**Proposed Temporary Animal Boarding Establishment (Dog Kennel)  
for a Period of 3 Years and Filling of Land at Lots 1347 S.W & 1347  
S.AD in D.D.107, Fung Kat Heung, Kam Tin, Yuen Long, N.T.**

Our response to the comments of the Transport Department is as follows:

With reference to email dated 4 October 2024 from Mr. Terence Tang of DSD, our response to the comments is as follows:

Figure 3

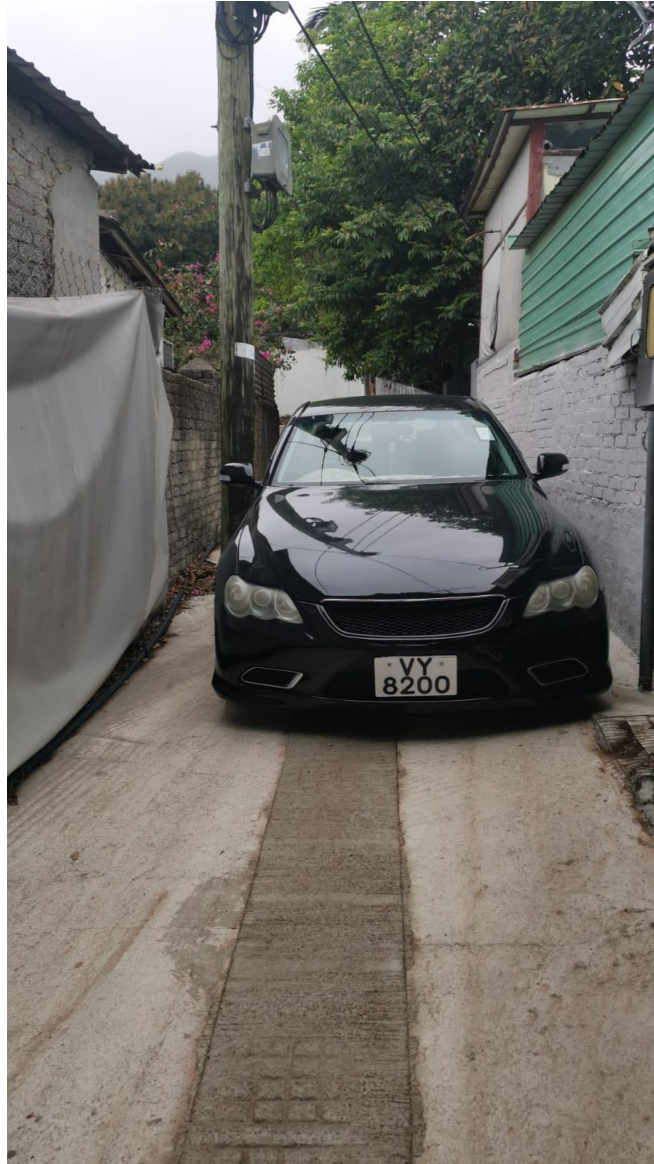
Transport Department's comments	Applicant's response
(a) The applicant should demonstrate the smooth manoeuvring of vehicles to / from the site. Reverse of vehicles in local road may induce road safety hazard;	Noted. Please refer to the swept path analysis in the attachment. The proposed parking spaces have been moved into the temporary structure so that manoeuvring space is available as shown in the updated Figure 3.
(b) The applicant should note the local access between San Tam Road and the site is not managed by this Department.	Noted.

Figure 4a – Intensity-Duration-Frequency Curves of HKO Headquarters  
(for durations not exceeding 4 hours)

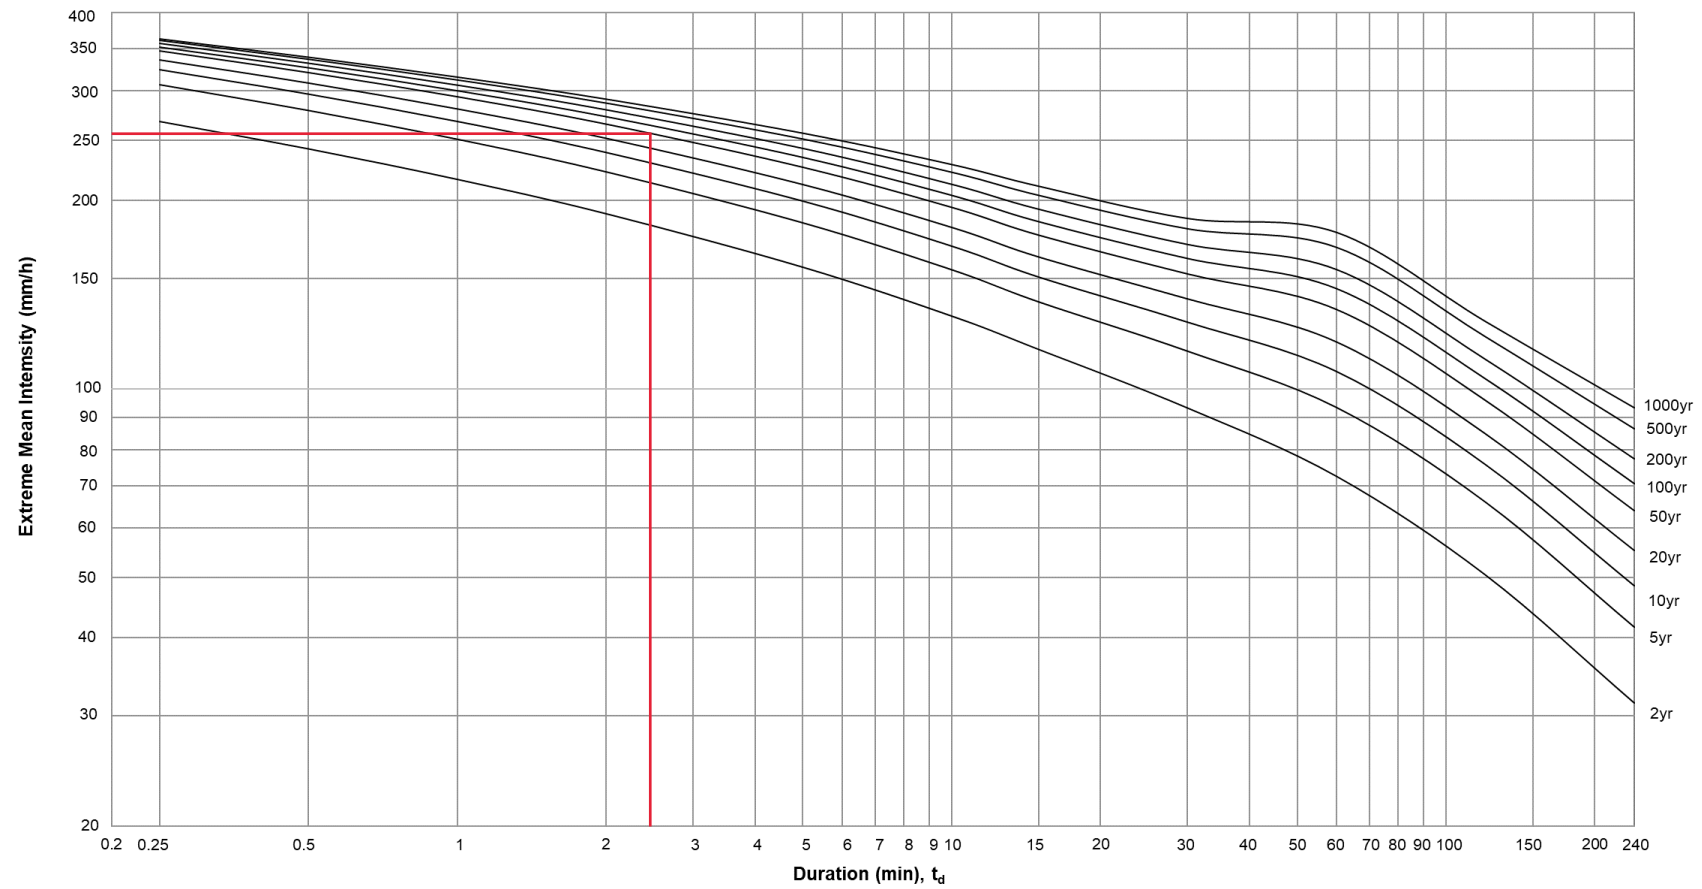
CE/MN, DSD's comments	Applicant's response
1. SDM corrigendum no. 1/2022 and 1/2024 should be considered.	Noted. <i>Intensity-Duration-Frequency Curves</i> has been updated.
2. GEO Technical Guidance Note No. 43 should be adopted for u-channel checking as Figure 8.7 of the Geotechnical Manual for Slopes (GCO, 1984) was superseded.	Noted. <i>Chart for the Rapid Design of Channels</i> has been updated.
3. Previous comment (d) has not been fully addressed. All proposed drainage facilities should be shown in cross sections.  (d) All proposed drainage facilities and walls/ hoarding should be shown in cross sections.	Noted, please refer to updated cross section.
4. Cross sections – Please also indicate the connection profile between proposed land filling and existing ground level.	Noted, please refer to updated cross section.

Figure 5

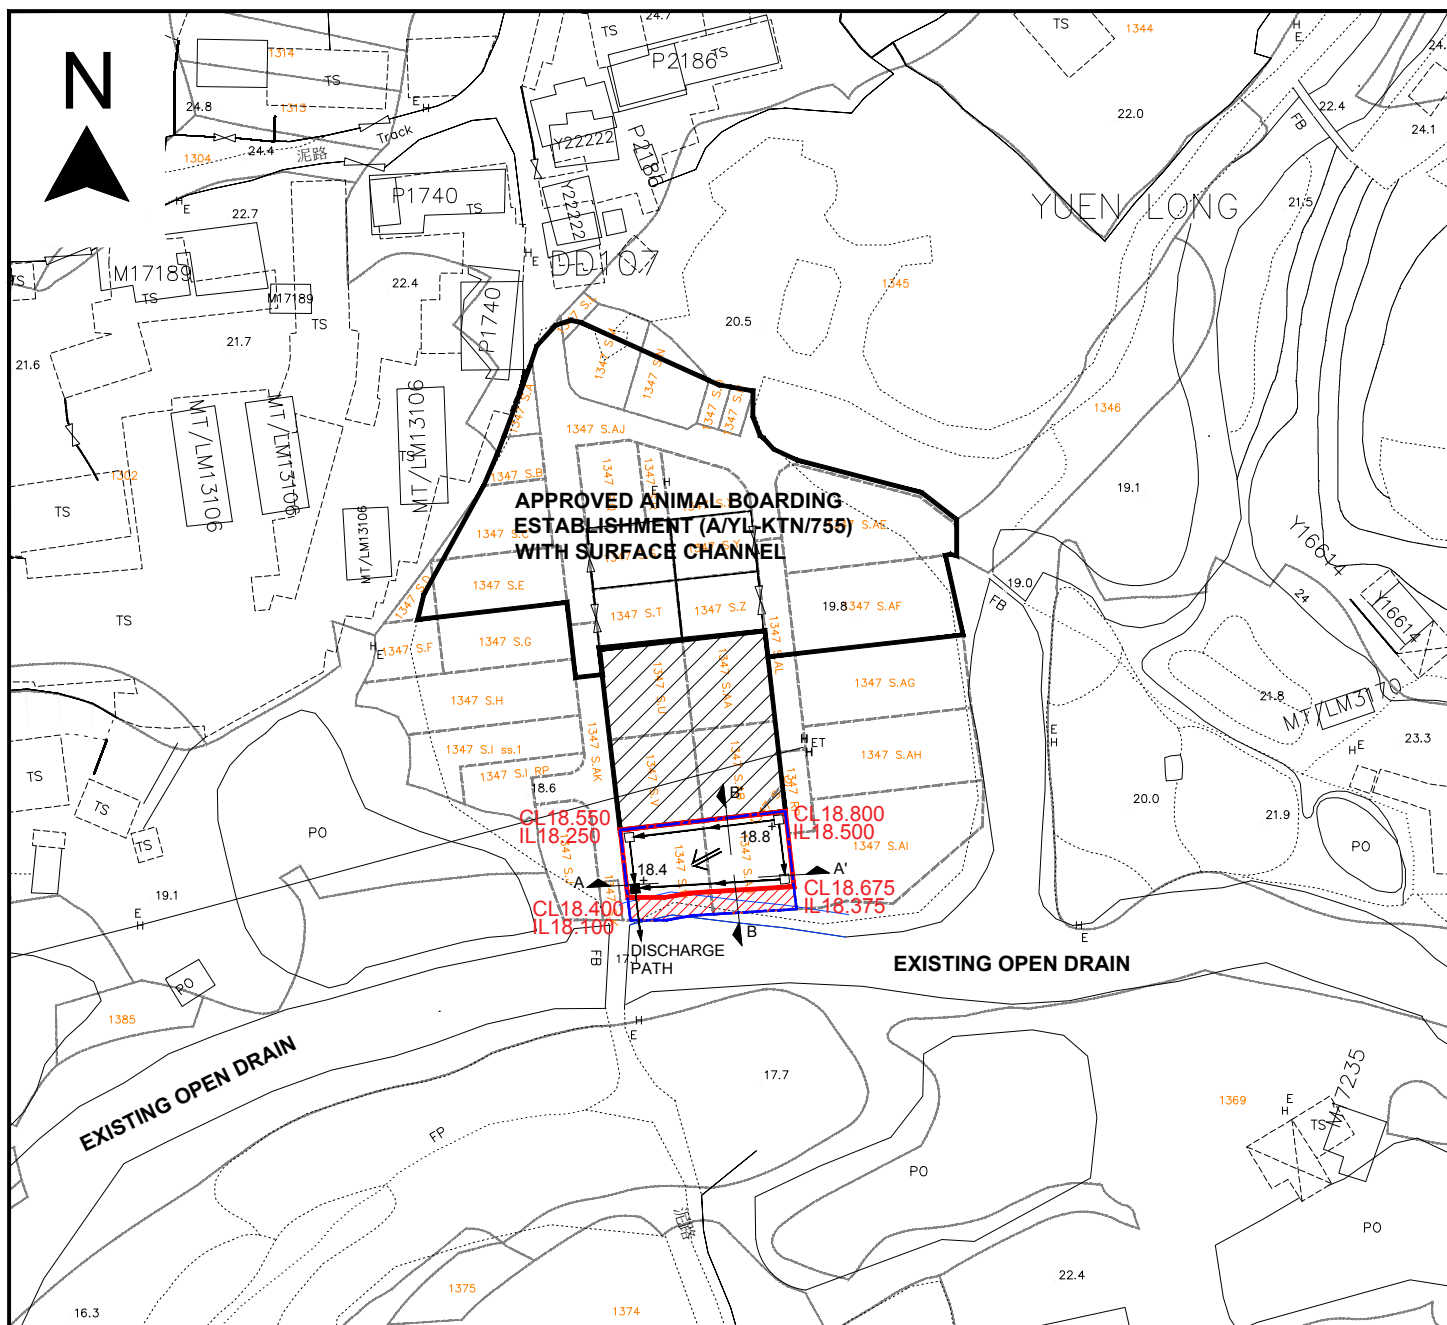
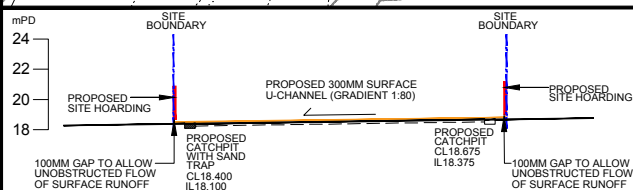
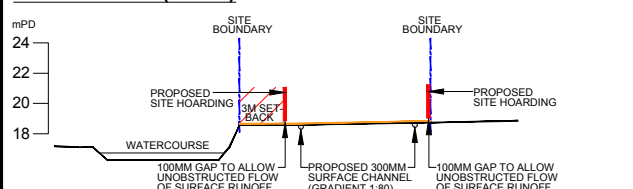
CE/MN, DSD’s comments	Applicant’s response
5. The applicant shall be required to place all the proposed works (including hoarding) 3m away from the top of bank of the streamcourse. Please indicate the 3m setback zone in all layout plan and cross sections	<p>Noted. A 3m setback zone has been indicated on the drainage plan in red hatch. Please also see the below site photos showing the 3m setback zone.</p>
